Access Compliance Report

Public Rights-of-Way

(Curb Ramps)

Intersection ID: 49130	Main Street: AUBURN_HILL_LN	Cross Street: WILTSHIRE_RIDGE_RD	Location: E
ADA ID: C01F6ED3BBF5	Ramp Type: Perp	Initial Pass/Fail: Fail	Overall Compliance: No
Severity Score: 12.5			
Codes/Mitigation Info/Possible Solution		Field Measurements/Component Compliance

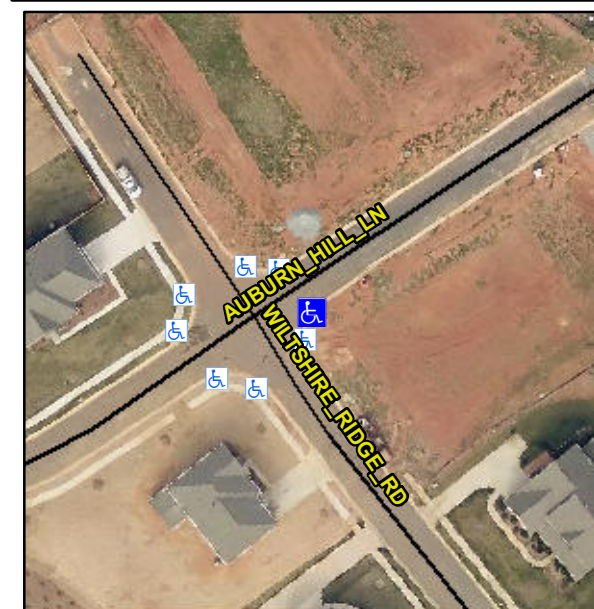
Not Found, R304.5.3

Compliance	Description	Data	Compliance	Description	Data
N/A	Ramp Length (in)	48.0	Yes	Ramp Slope (%)	5.1
Yes	Ramp Width (in)	48.0	No	Ramp XSlope (%)	5.5
N/A	Flare Type LT	N/A	N/A	Flare Type RT	N/A
N/A	Flare Slope LT (%)	N/A	N/A	Flare Slope RT (%)	N/A
N/A	Flare Traversable LT?	N/A	N/A	Flare Traversable RT?	N/A
N/A	Landing Length (in)	N/A	N/A	DWS Provided?	N/A
N/A	Landing Width (in)	N/A	N/A	DWS Contrast?	N/A
N/A	Landing Slope (%)	N/A	N/A	DWS Length (in)	N/A
N/A	Landing X Slope (%)	N/A	N/A	DWS Full Width?	N/A
N/A	Landing Curb? (Y/N)	N/A	N/A	DWS Offset (in)	N/A
N/A	Shared Landing?	N/A			
N/A	Gutter Ponding?	N/A	N/A	Gutter Slope (%)	N/A
N/A	Gutter Lip Ht (in)	N/A	N/A	Gutter X Slope (%)	N/A
N/A	Painted X Walk1?	No	N/A	Painted X Walk2?	N/A
	X Walk 1 Direction	To NW		X Walk 2 Direction	N/A
N/A	X Walk 1 Width (in)	N/A	N/A	X Walk 2 Width (in)	N/A
	X Walk 1 Slope (%)	8.4		X Walk 2 Slope (%)	N/A
	X Walk 1 X Slope (%)	7.8		X Walk 2 X Slope (%)	N/A

Remove & Replace Entire Ramp.
